Application for an Individual Section 401 Water Quality Certification, Individual Section 404 Permit and CAMA Major Permit for the construction of US 158 from the Murfreesboro Bypass to US 13 west of Winton, Hertford County, TIP No. R-2583, State Project No. 6.079007T

Meeting Name: R-2583 (Design-Build) CP 4C Permit Drawing Review Meeting

HERTFORD COUNTY
PROJECT: 35489.3.1 R-2583

SITE 15

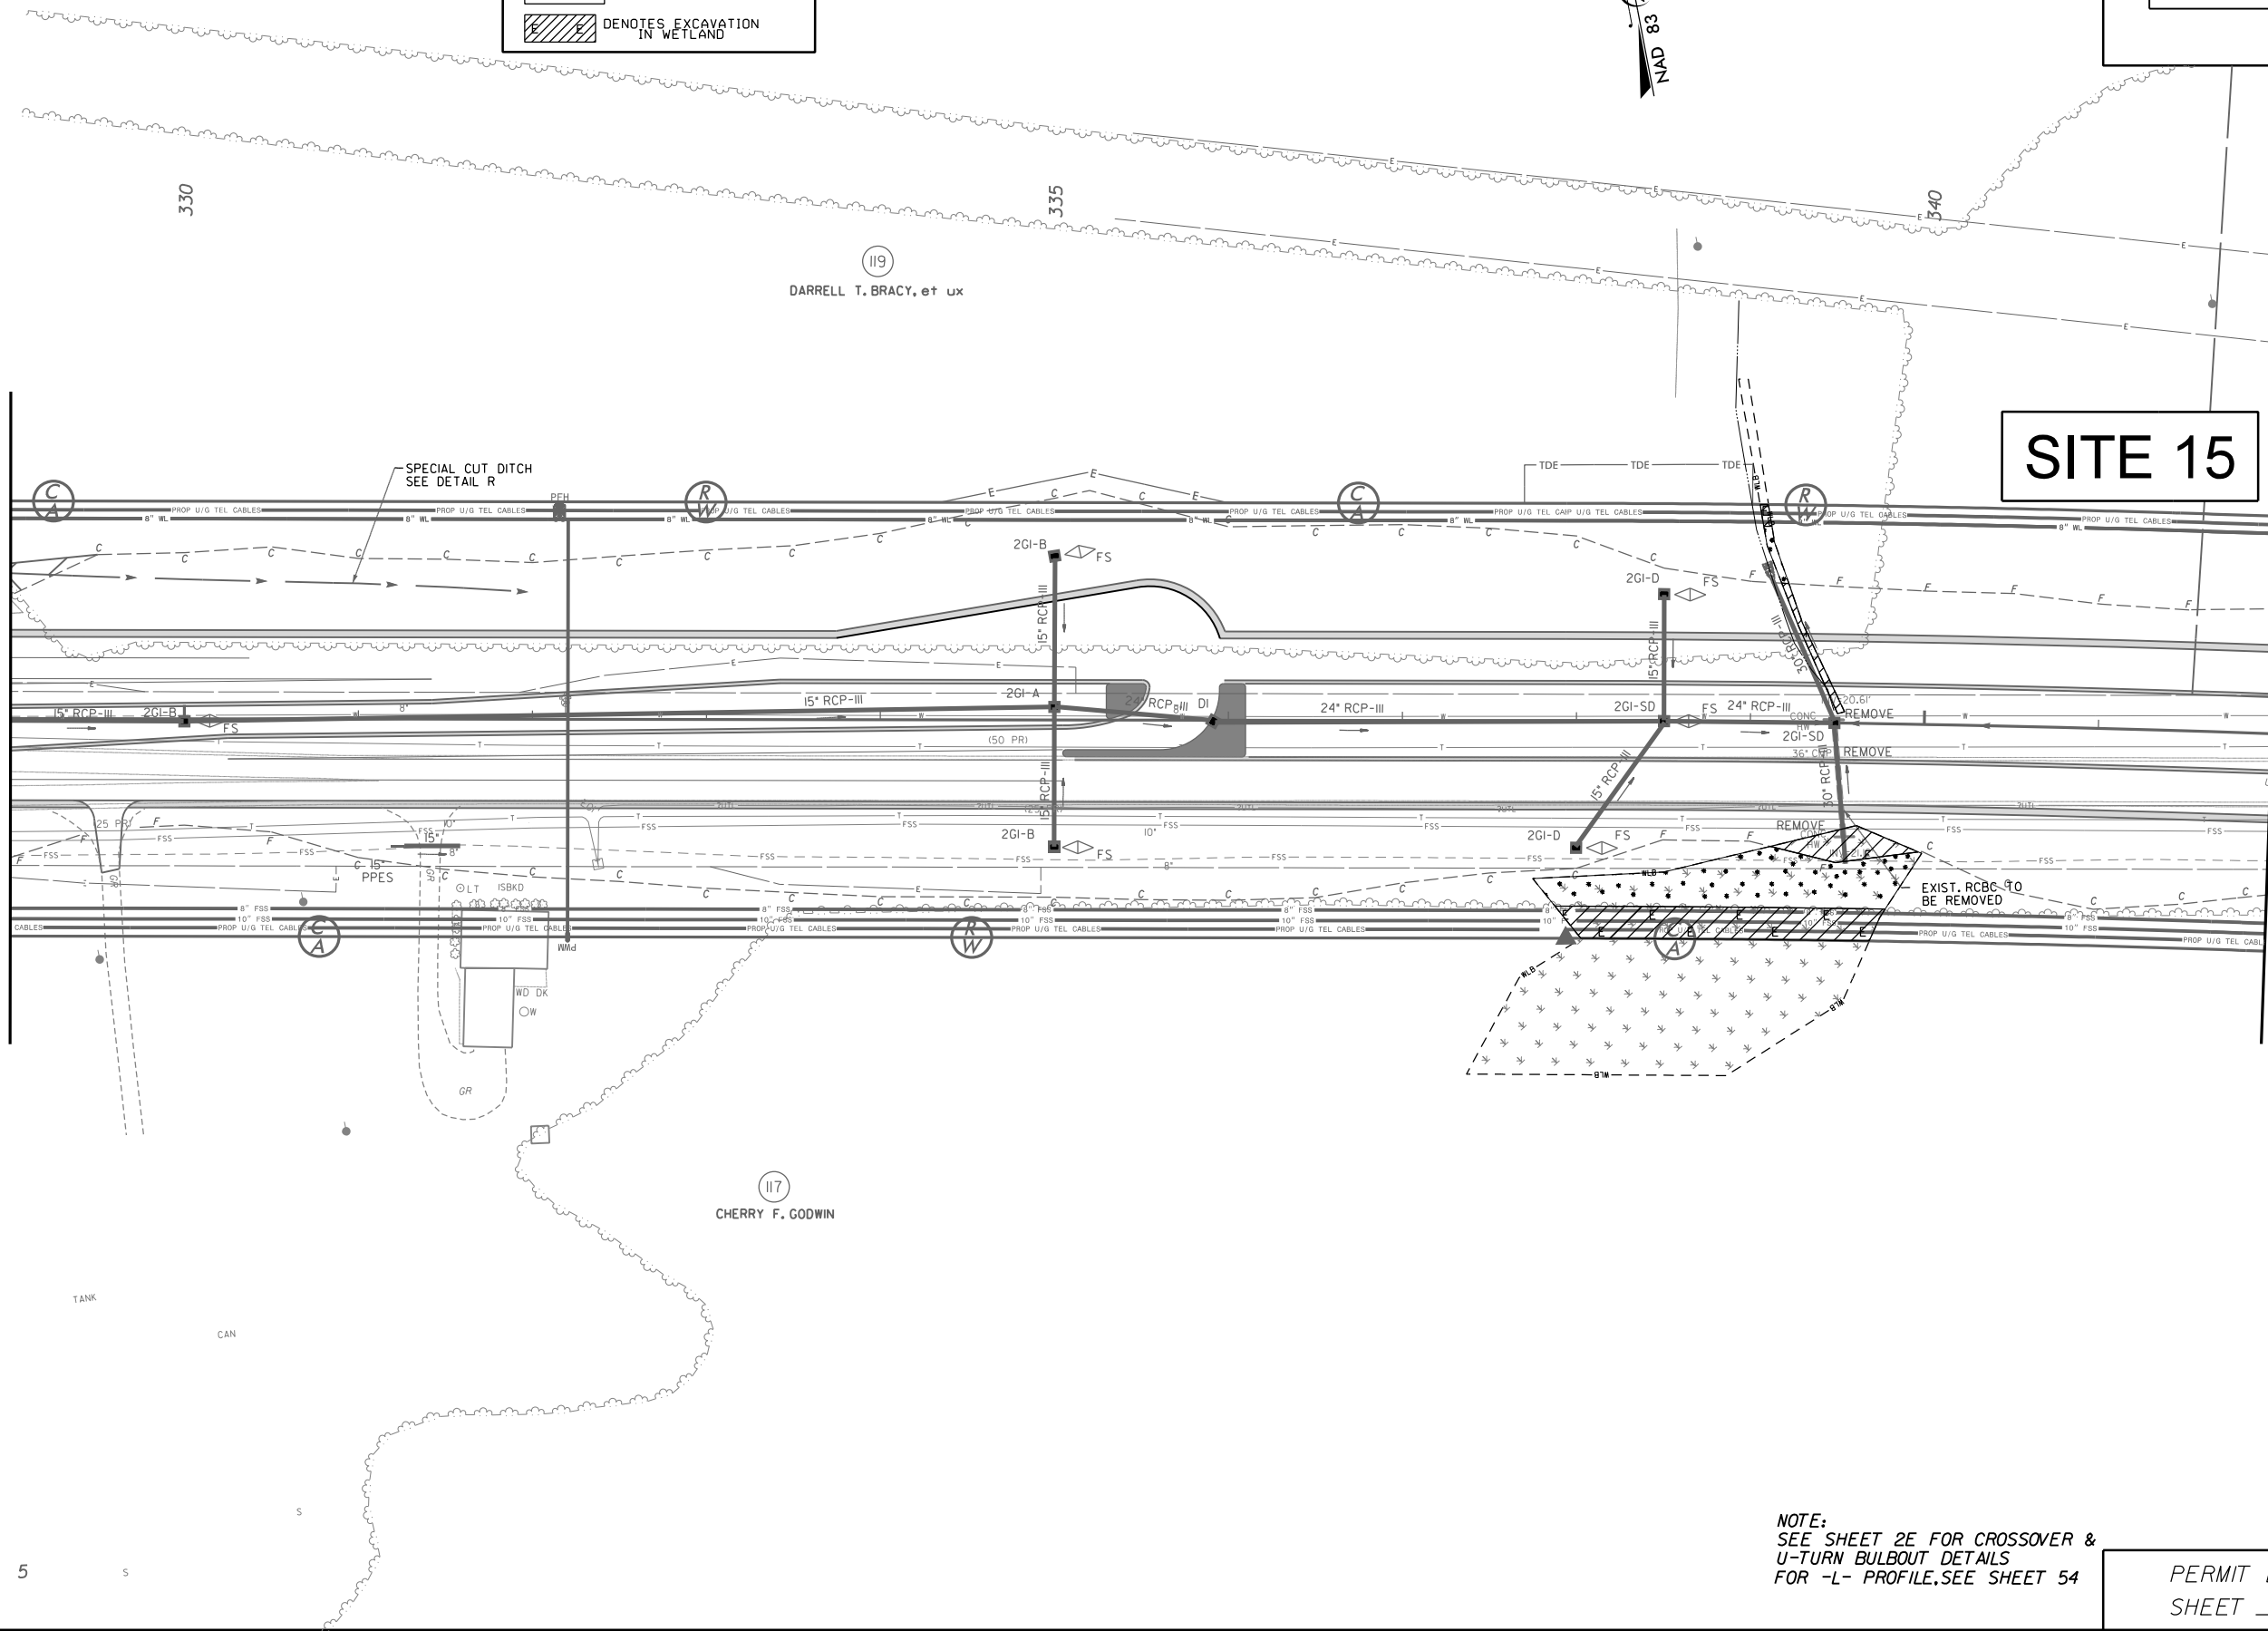
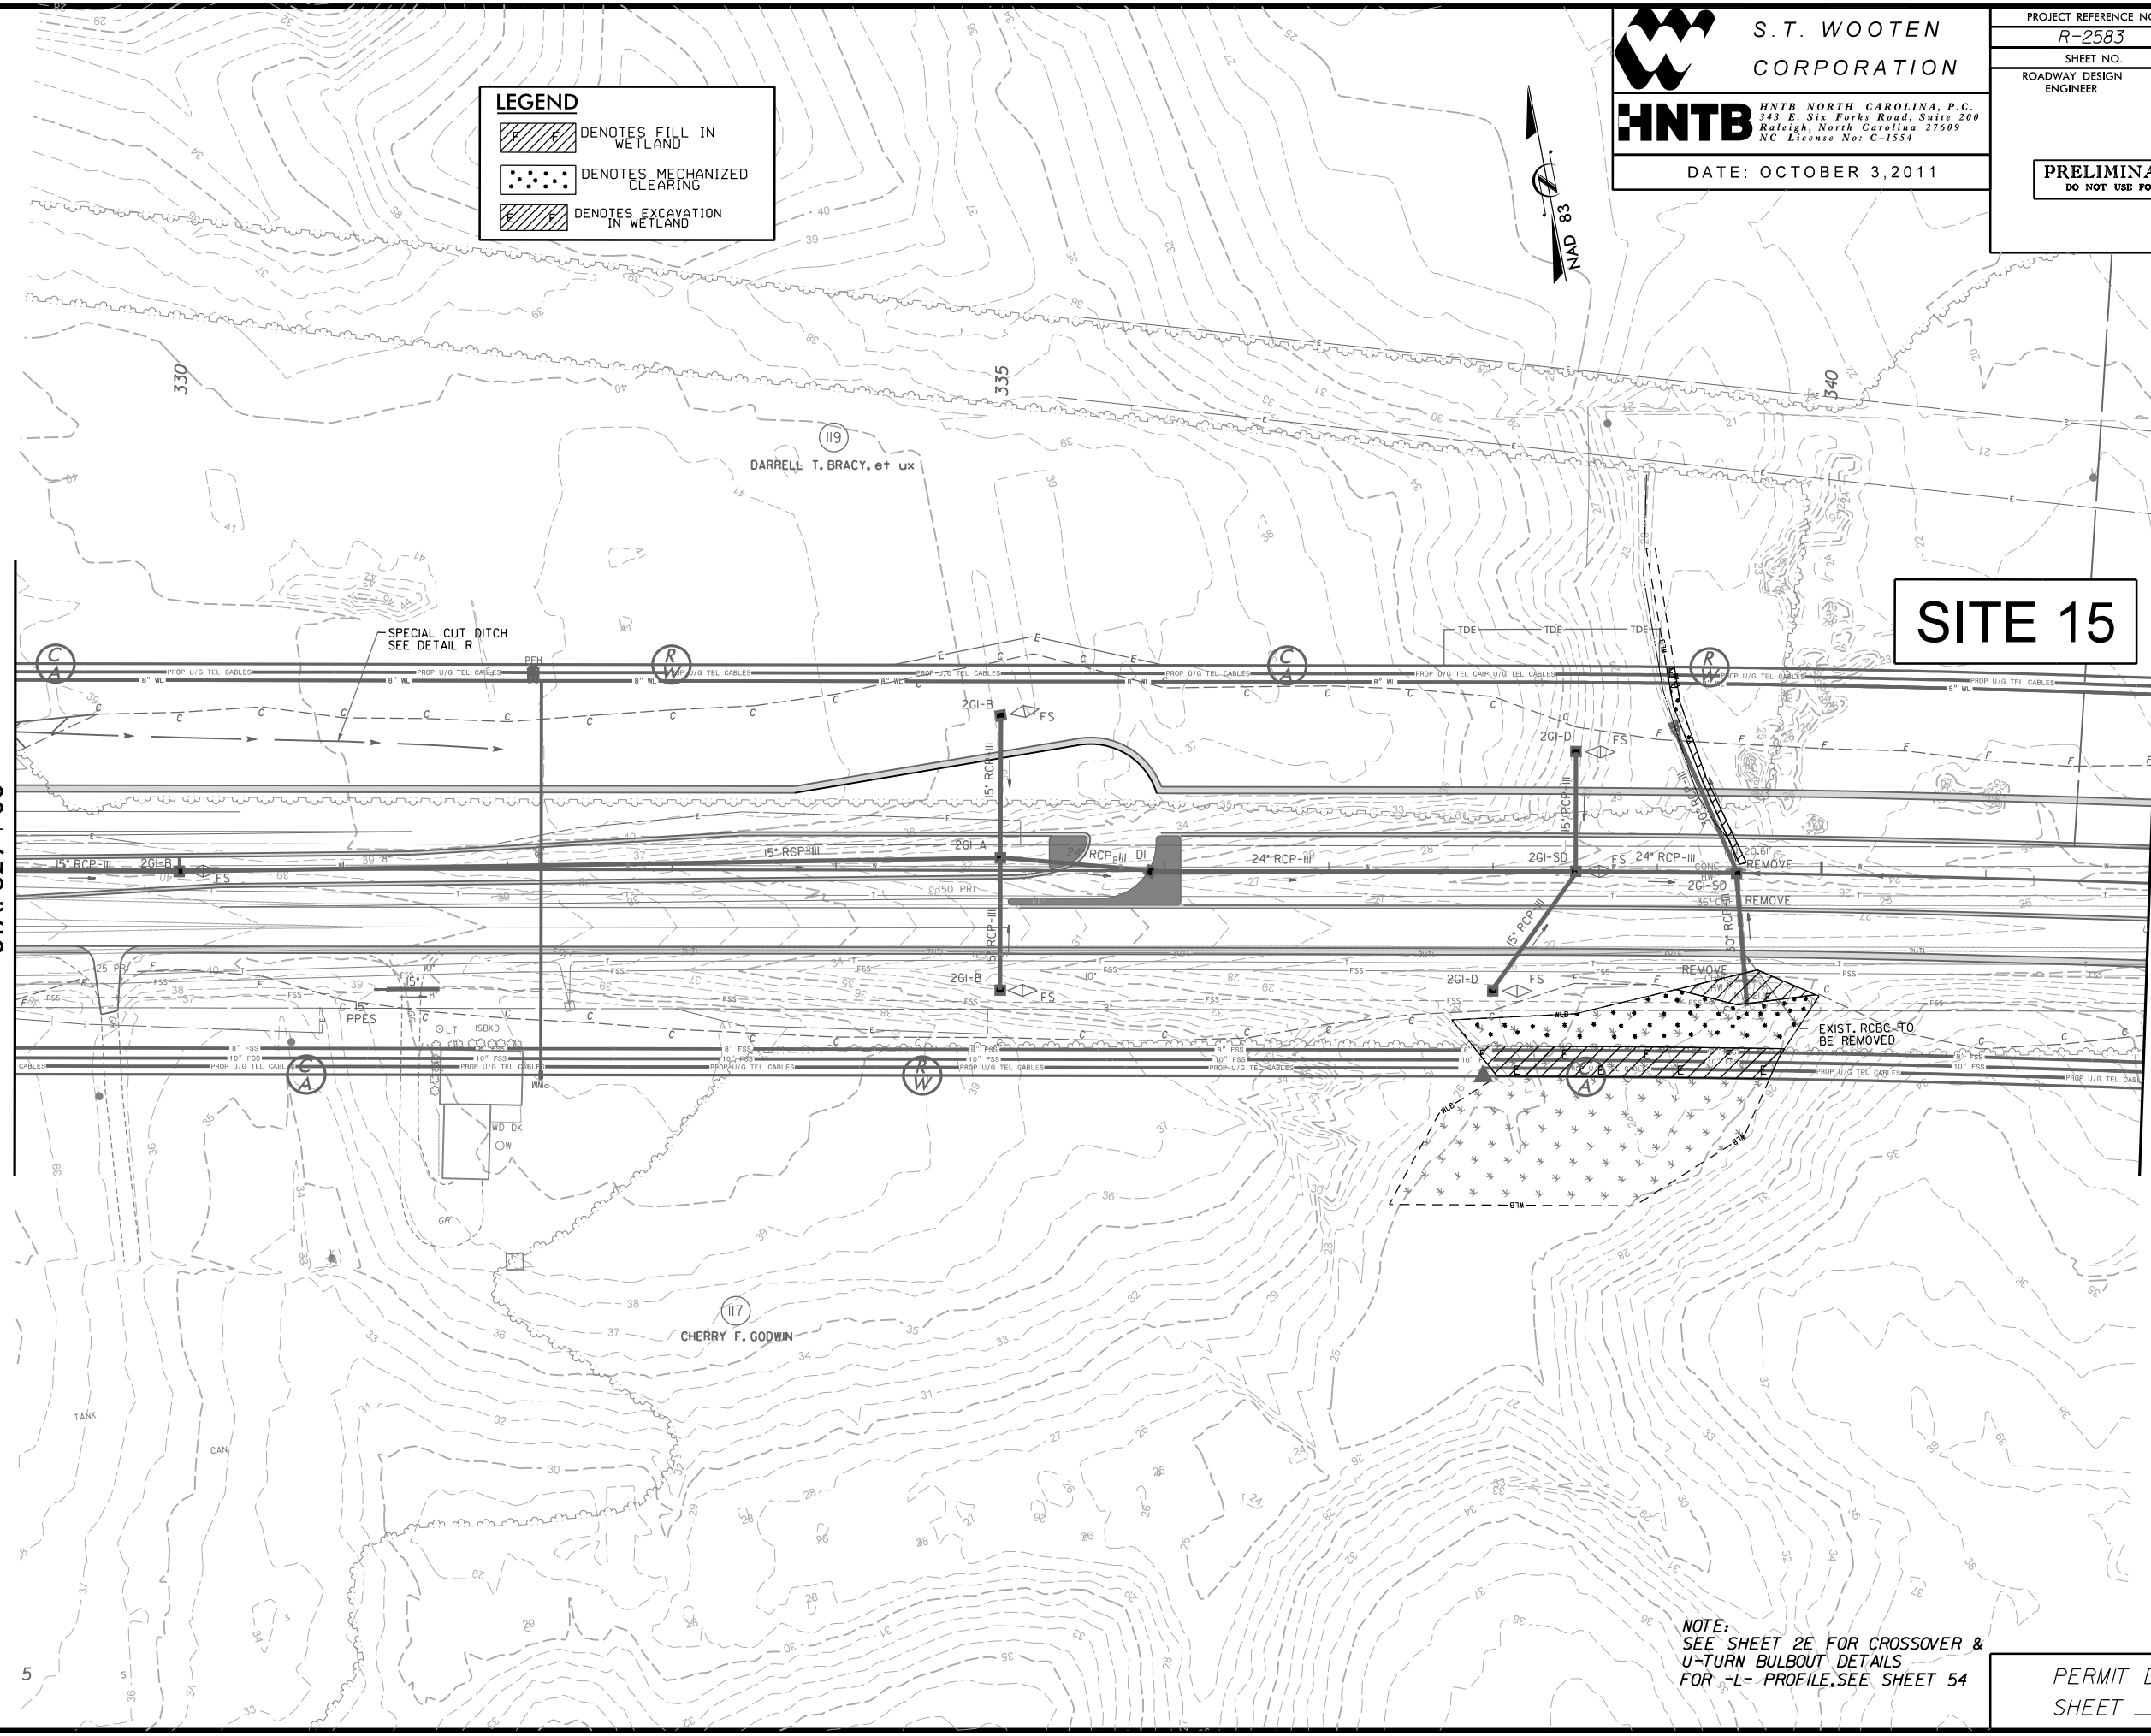
- **Site 13**
 - There were no questions for this site.
- **Site 14**
 - There were no questions for this site.
- **Site 15**
 - Mr. Biddlecome requested that the area right of Sta. 339+00 include excavation in wetlands where trenching will be required in order to install utilities. It was also requested that wetland impacts be shown accordingly for all similar sites. The D-B team agreed to revise the permit drawings and update the impact summary accordingly.
